**Response to Written Comments  
Draft Waste Discharge Requirements  
Order No. R1-2023-0014  
National Pollutant Discharge Elimination System (NPDES)  
for the  
Fall Creek Hatchery  
Regional Water Quality Control Board, North Coast Region  
April 6, 2023**

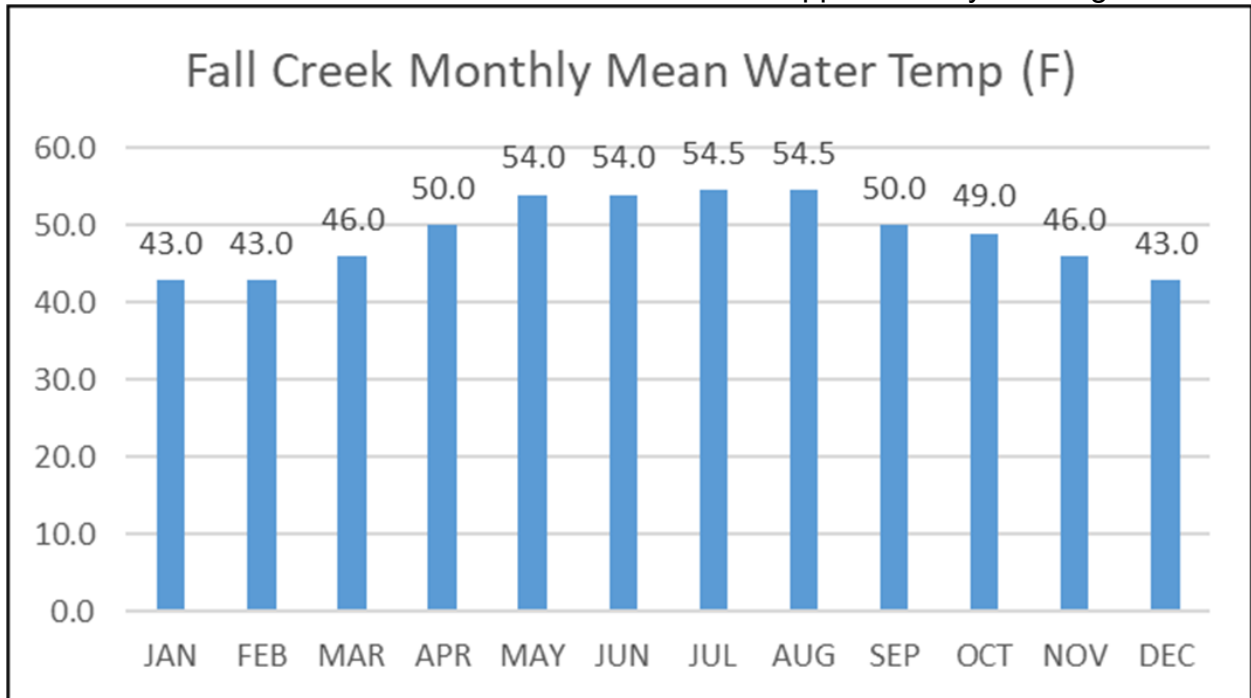
CDFW is concerned that the limits for dissolved oxygen (DO) in receiving waters may be too low. The information below shows Fall Creek mean monthly temperatures, and a table showing 100% DO saturation at elevation and temperature.

The elevation of the proposed FCH is approximately 2,215 feet above sea level.

- The lowest mean monthly water temperature occurs in December, January and February annually and is 43.0 F.
  - At 43.0 F
    - 100% Fall Creek DO saturation is approximately 11.44 mg/L.

- 85% Fall Creek DO saturation is approximately 9.73 mg/L.
- The highest mean monthly water temperature occurs in July and August annually and is approximately 54.5 F.
  - At 54.5 F
    - 100% Fall Creek DO saturation is approximately 9.82 mg/L.
    - 85% Fall Creek DO saturation is approximately 8.35 mg/L.

According to the data above, during the warmer and drier months, receiving waters in Fall Creek could very likely already be below 9.0 mg/L. CDFW requests further consideration of the lower DO levels, given the information above.

**Response 7:** *Regional Water Board staff incorrectly included dissolved oxygen (DO) surface water limitations in the Draft Permit as established in section 3.3.5 of the Basin Plan. Table 3-1a of the Basin Plan includes waterbody-specific objectives for DO in the mainstem of the Klamath River. Therefore, section 5.1.1 of the Proposed Permit has been modified as follows.*

*“The discharge shall not cause the dissolved oxygen (DO) concentration of the receiving water to be depressed below 9.0 mg/L 85 percent DO saturation April 1 through September 30 and below 90 percent DO saturation October 1 through March 31 based on natural receiving water temperatures.”*

*It is important to recognize that the objective states that the discharge does not cause DO concentration of the receiving water to be depressed below the specified saturation values. Staff recognize the concern of the Permittee in meeting the dissolved oxygen (DO) surface water limitation from the North Coast Basin Plan (Basin Plan).*

*Monitoring data will be evaluated to determine if the Facility is the cause of the exceedance of the DO surface water limitation. Any exceedances of the DO surface water limitation would not be subject to mandatory minimum penalties. Enforcement would be determined at the Board's discretion.*
